FOOTE LAW
FIRM, LLC

March 6, 2025

The Northern Colorado Partners for Clean Energy (NCP4CE) submits the following comments regarding Platte River Power Authority's (PRPA) 1041 Permit Application for five new aeroderivative combustion turbines and related infrastructure at the Rawhide site. The application is 24-ZONE3715. NC4PCE respectfully asks you to deny PRPA's 1041 application because it fails to meet Sections 10.1.9.E and 10.1.9.C of Larimer County's Land Use Code (LUC).

Figure 4: comparison of emissions reductions of PRPA's five portfolios (IRP Figure 58)

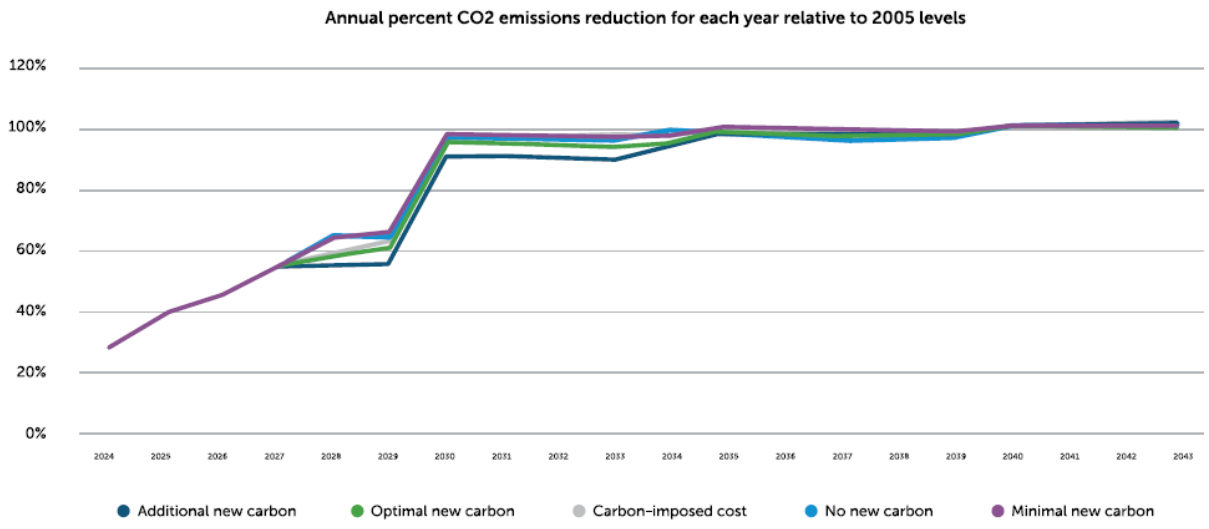
The "carbon-imposed cost" portfolio increased its solar allocation by 50 MW and increased 4-hour battery storage by 100 MW over the "optimal carbon" portfolio in return for a reduction of new gas generation by 40 MW. Figure 2 on page 11 of this letter shows a graphical comparison between these two scenarios. As illustrated in the two additional figures below, PRPA found its "carbon-cost" portfolio would be virtually identical in costs and provide better short-term emissions reductions to its "optimal carbon" portfolio.

However, PRPA recommended the adoption of its "optimal carbon" portfolio – the one with an additional 40+ MW of gas generation – even though the "carbon-imposed costs" portfolio presented a cost-effective and workable path forward.[27] The sum of PRPA's reasoning for picking the cost-effective and workable portfolio with more emissions was this: "[w]hile this portfolio is reliable for the historically experienced weather uncertainties, it may not be reliable if weather events continue to become more extreme as they have in the recent past."[28] The IRP contained no further analysis on the point, and consistent with the rest of the IRP excluded any mention of the role the SPP-West wholesale power market may play in providing power in case of a vaguely referenced future extreme weather event.

Figure 5: PRPA's air permit operating hours representation[35]

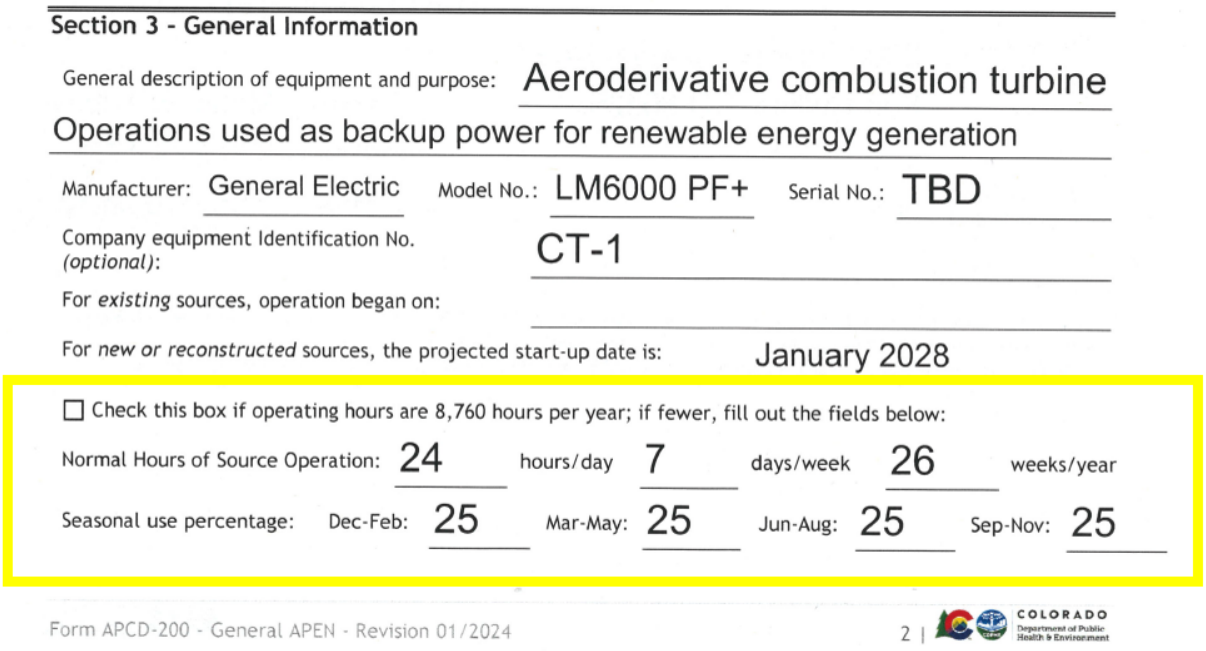
PRPA's application did not address the impact of its proposed new gas turbines on Larimer County's ozone problem. It did not model the impact of its new gas emissions on ozone nonattainment. It barely mentioned ozone at all. Most importantly, it failed to propose any minimization measures for ozone season or ozone action days.[34] PRPA's Air Pollution Emissions Notices (APEN) filed with the Colorado Department of Public Health and Environment are instructive to this point. PRPA has sought permission from the state – and Larimer County through this 1041 application – to run each of its five new gas turbines for up to 4,380 hours each year (26 weeks at 24 hours a day 7 days a week). PRPA would like those 4,380 hours to be split evenly between seasons, so 25% from December through February, 25% from March through May, 25% from June through August, and 25% from September through November. The period between June and August is typically marked by dozens of days where ozone is at unhealthy levels in Larimer County and the rest of the nonattainment area, exceeding the daily ozone standards. Yet PRPA wants approval to run its new turbines up to 1,095 hours during the season with highest ozone concentrations. The relevant section of PRPA's APEN filing is highlighted in Figure 5, below.

Seasonal limitations on operations in the ozone nonattainment area are common. They include use restrictions on gasoline-powered lawn and garden equipment, oil and gas extraction activity limitations, and voluntary reductions in driving activities by the general public, among others.[36] PRPA has not proposed any kind of seasonal limitation to minimize ozone impacts caused by its proposed new gas turbines. Combined with the prospect of PRPA selling power generated from its new gas turbines to customers outside of its four-city service area, this means Larimer County will not only feel the impacts of emissions for someone else's power generally, but it will feel the impacts of those emissions on the worst possible days of the ozone season.

PRPA's lack of ozone minimization strategies does not adequately protect air quality and violates Section 10.9.1.E.
